SEPTIC: IMPROVEMENT PERMIT / AUTHORIZATION TO CONSTRUCT / OPERATION PERMIT / EXISTING SYSTEM

PERMIT: OSWP 2024-47391

118 PRESERVE WAY, MOORESVILLE NC.
SECTION -, LOT 13 THE COVE AT CHESAPEAKE POINTE

BOSS	Benfield Outdoor Services & Solutions, LLC 939 Brawley School Rd, Mooresville, NC 28117 Ph:704-380-0376 info@yardsbyboss.com	KELLY VOGEL	**LOT 13** 118 PRESERVE WAY, MOORESVILLE, NC IREDELL COUNTY DATE: 2/19/24 DRAWN BY: MDB REVIEWED BY: MES

AS BUILT SKETCH

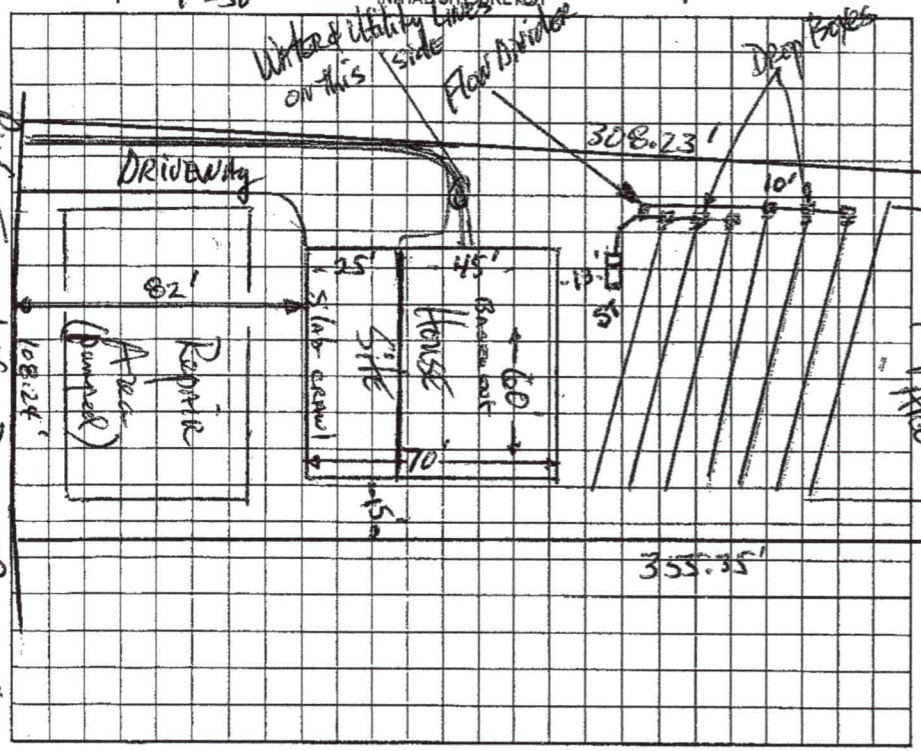
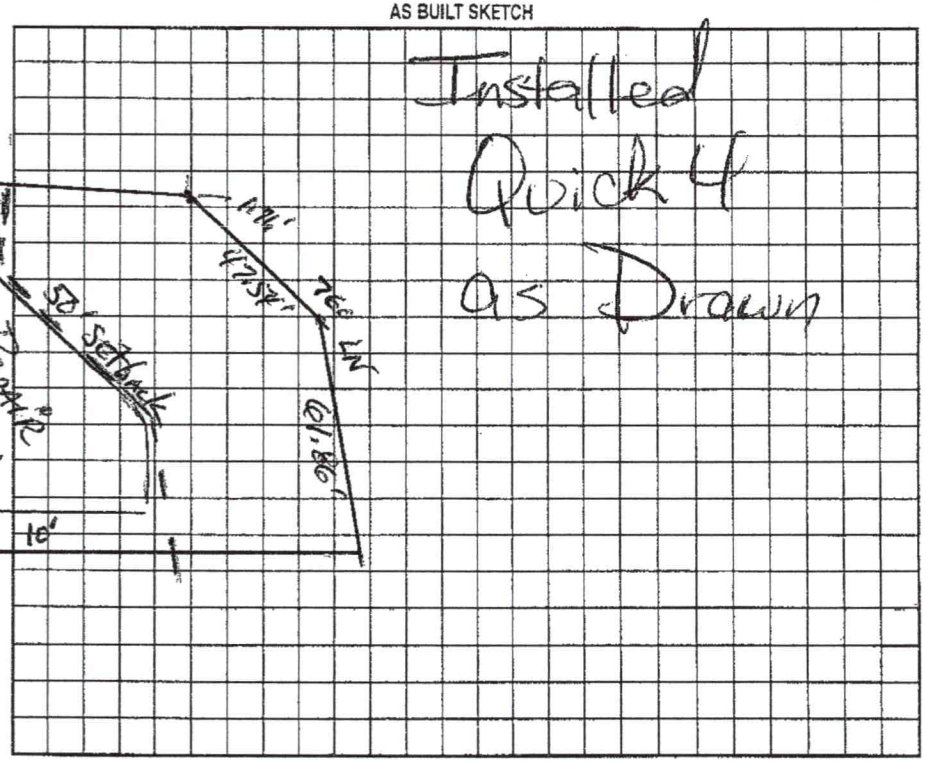
Comments:/Conditions: 200' of Lateral minimum off each side of Flow Divider

7/17/06 Reviewed Building plans, essentially in compliance with original permit.

Comments:/Conditions: (PARTIAL) Checked tanks & lines 10/3/06 MC

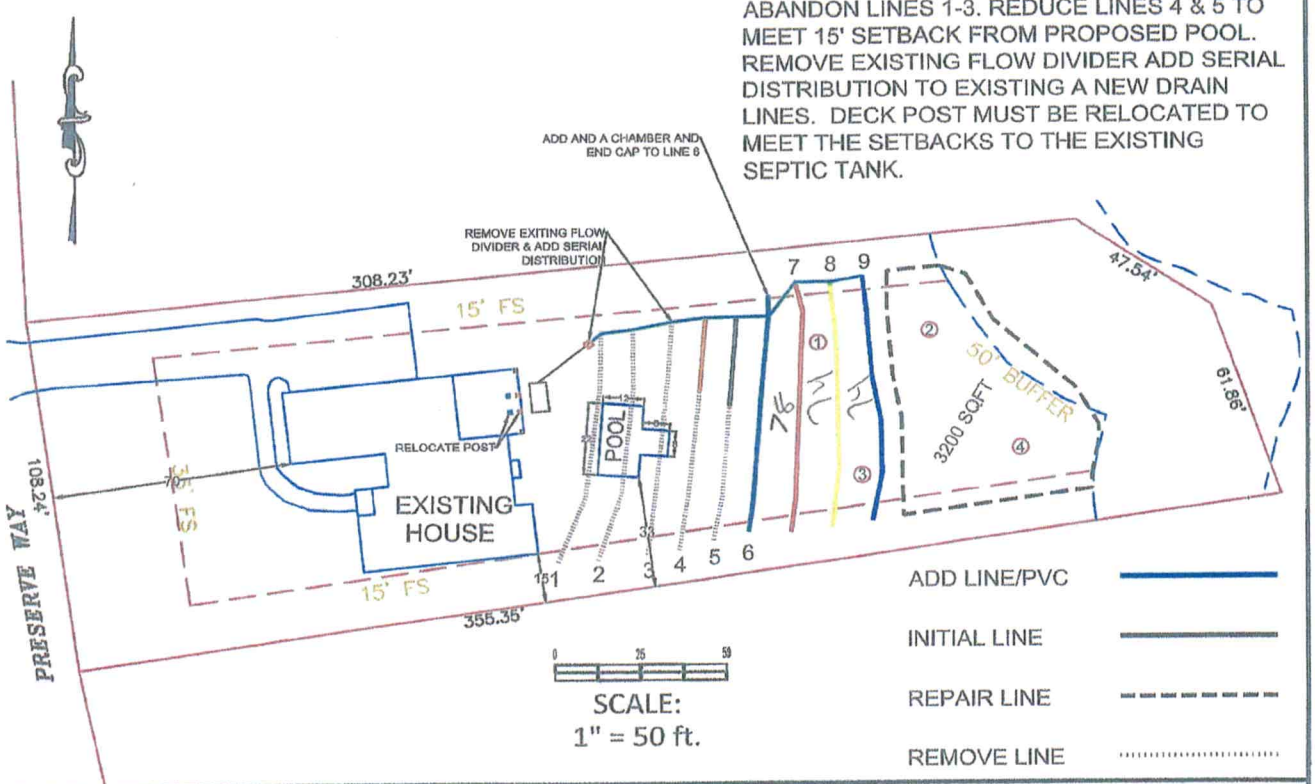
LINE NUMBER	COLOR	FIELD ELEVATION	LENGTH (FT)	DESIGN LENGTH (FT)
1	EXISTING P	1.2	70	0
2	EXISTING O	2.1	70	0
3	EXISTING Y	3.1	74	0
4	EXISTING O	4.5	70	~~22~~ 18
5	EXISTING W	5.9	66	26
6	EXISTING G	7.3	66	~~X~~ 75
7	PINK	9.7	36	78
8	YELLOW	11.7	42	74
9	BLUE	13.4	75	74
			TOTAL	TOTAL
			569	345

EXISTING 4-BEDROOM GRAVITY 25% RED
LINES 4-6, TOTAL 119 LINEAR FT
ADD LINES 7-9 GRAVITY 25% RED SYSTEM
TOTAL 345 LINEAR FT
LTAR 0.35
25% REDUCTION 9' OC
MAX TRENCH BOTTOM
HIGH SIDE 36" LOW SIDE 31"

INFORMATION FOR INSTALLER:
ABANDON LINES 1-3. REDUCE LINES 4 & 5 TO MEET 15' SETBACK FROM PROPOSED POOL. REMOVE EXISTING FLOW DIVIDER ADD SERIAL DISTRIBUTION TO EXISTING A NEW DRAIN LINES. DECK POST MUST BE RELOCATED TO MEET THE SETBACKS TO THE EXISTING SEPTIC TANK.
